Lower Rear Door Cover Protrudes In Area Of Rear Wheel Arch

Topic number	LI72.12-P-078483
Version	1
Function group	72.12 - Rear door
Date	10/23/24
Validity	H247 as of production date 04.12.2023 from Rastatt plant
Reason for change

Attachments	
File	Description
Bild 1.jpg	Rear door cover protrudes in area of rear wheel arch

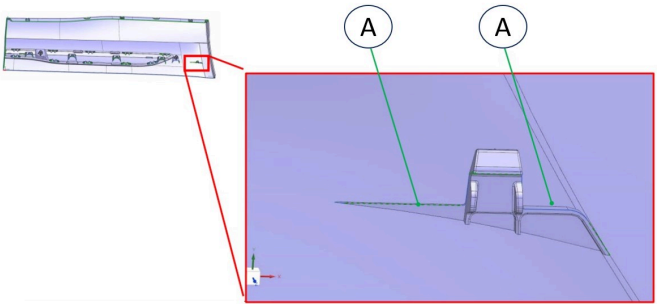
Lower rear door cover protrudes in area of rear wheel arch. Left and right vehicle side could be affected. See Figure 1

Rear catch tab of the rear door cover cannot fully engage, causing the component part to protrude.

Order new component part and, before installing the new part, shorten the contact ribs on the rear catch tab by 1 mm (A). See Figure 2.
